Fiat Scudo - Poor air conditioning system performance | HELLA

Scudo 1.6D Multijet 90

Poor air conditioning system performance

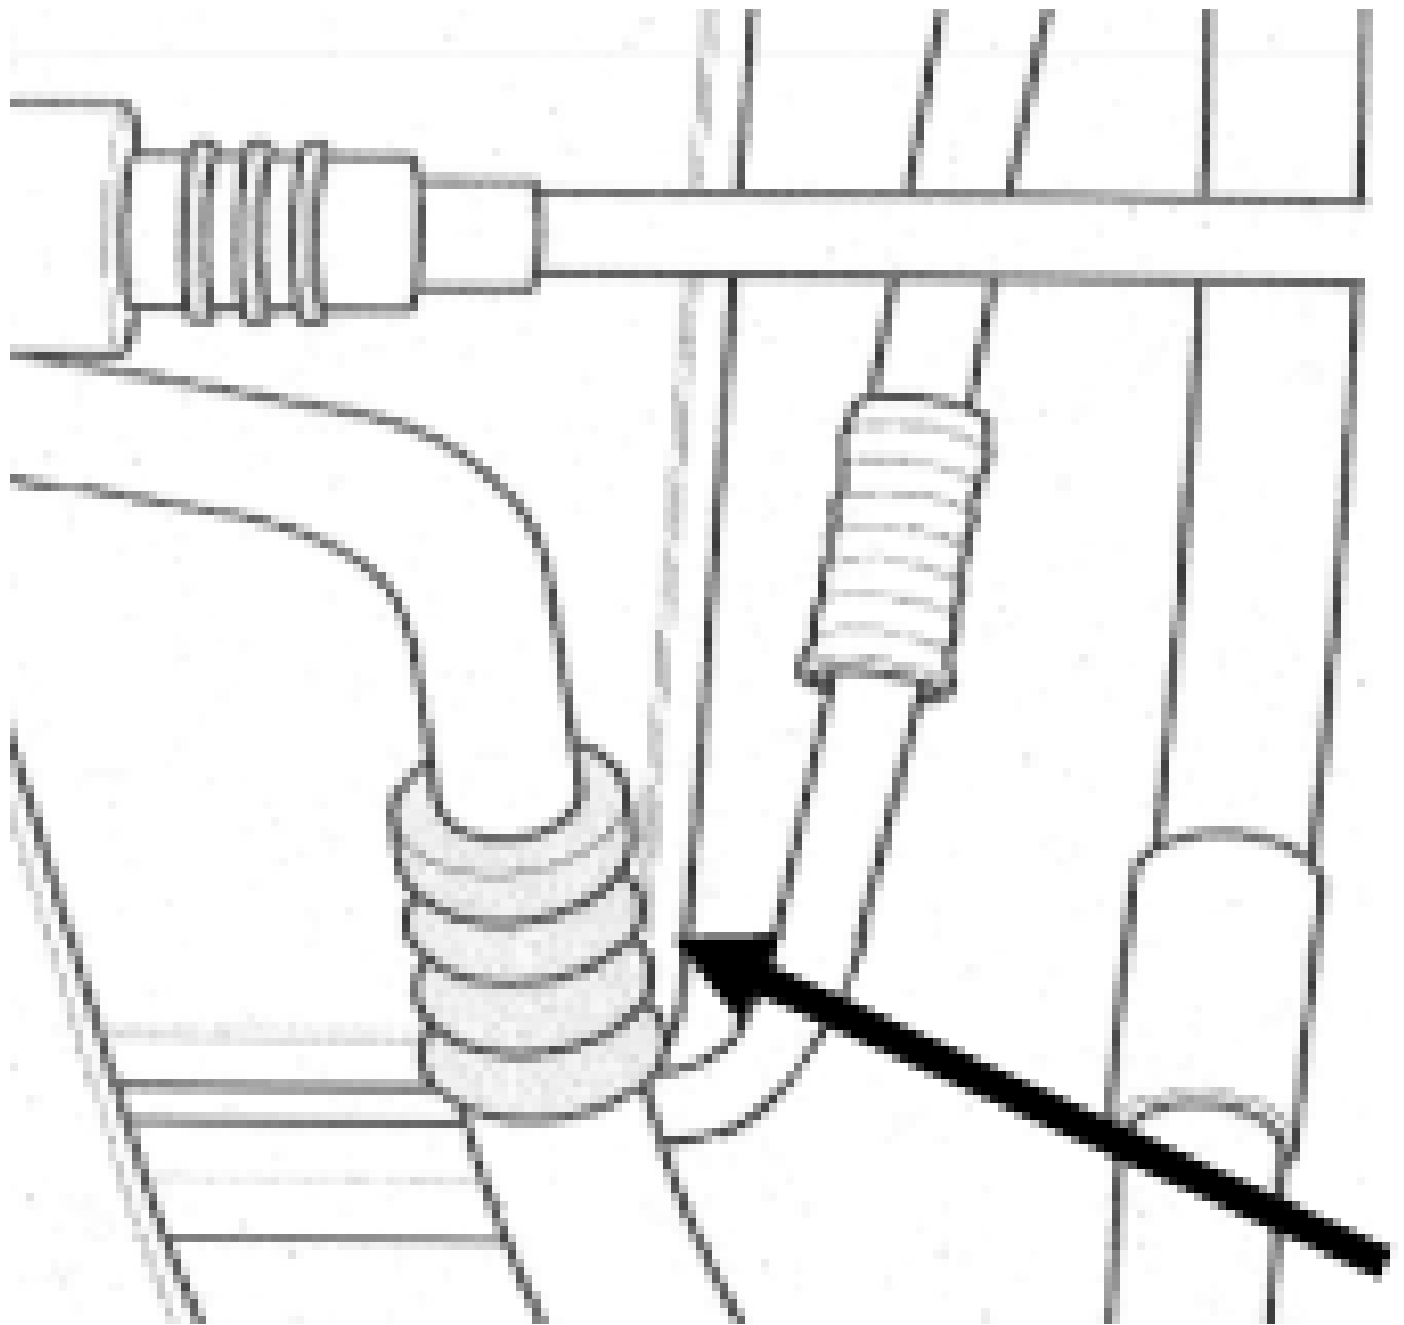
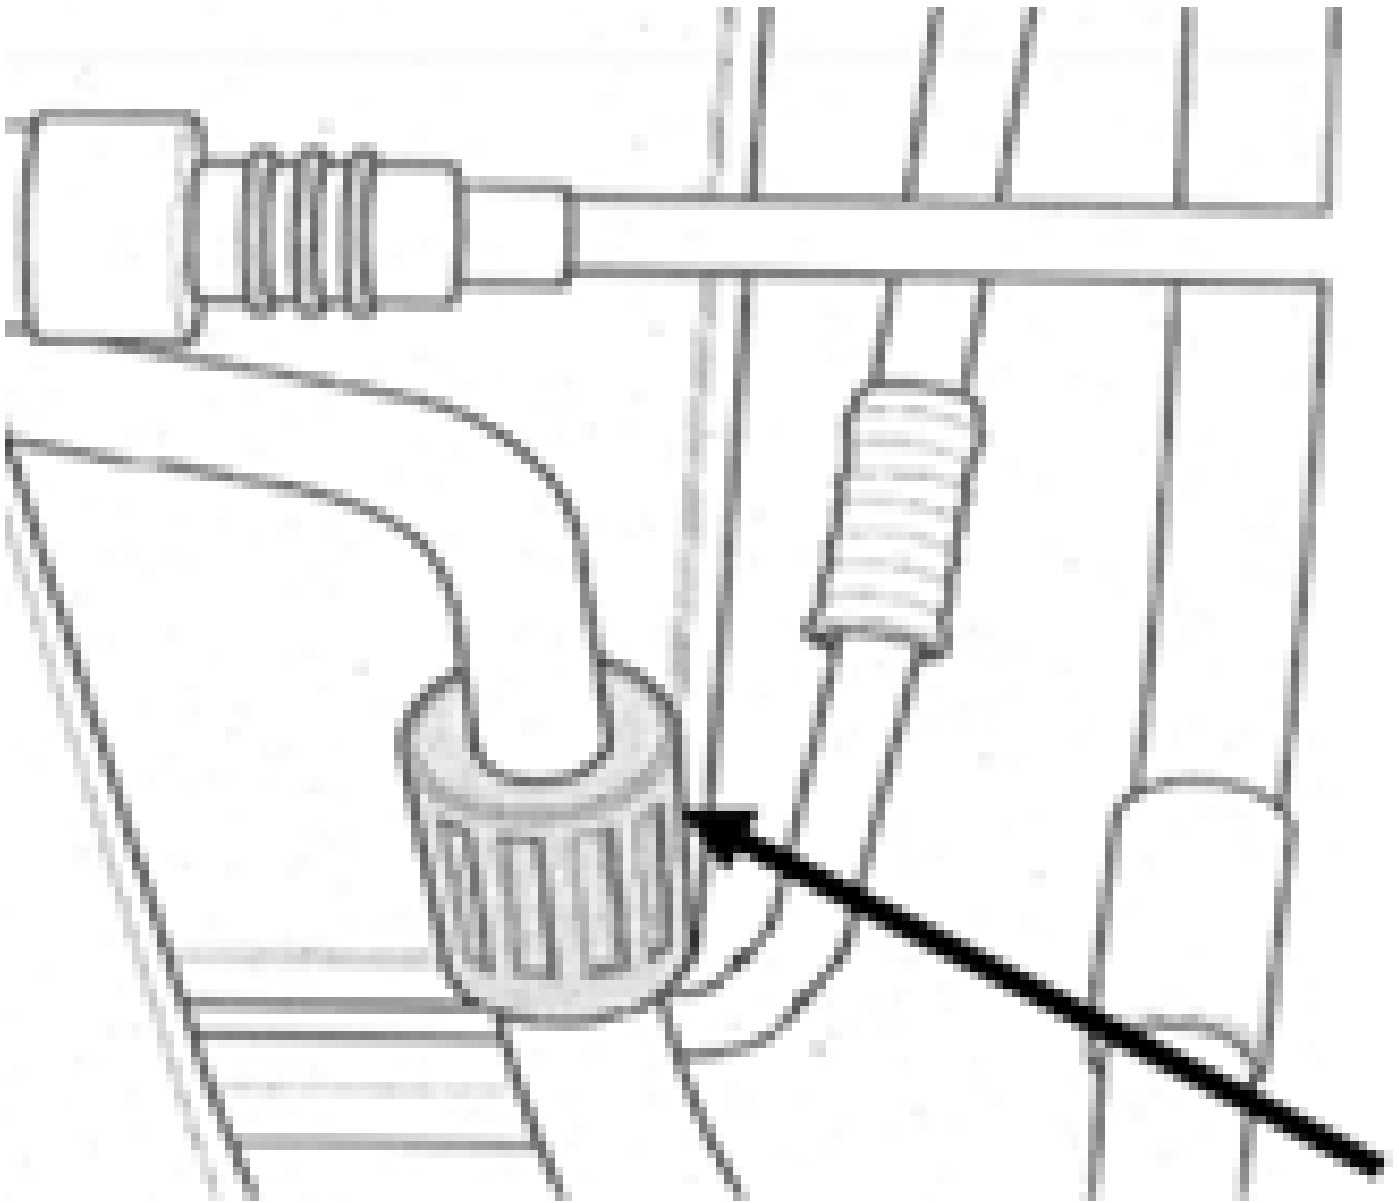
If the vehicles mentioned above experience poor air conditioning performance or a loss of coolant, the possibility of a coolant leakage between the condenser and compressor must be considered.

Check the coolant line for the correct model type and replace if necessary. (see figures)

- Old model types -

This is the modified model type from the vehicle manufacturer: [Spare parts]

- 1 unit: Coolant line: (Spare parts): 140142280

- 2 units: O-ring: (Spare parts): 9645950980
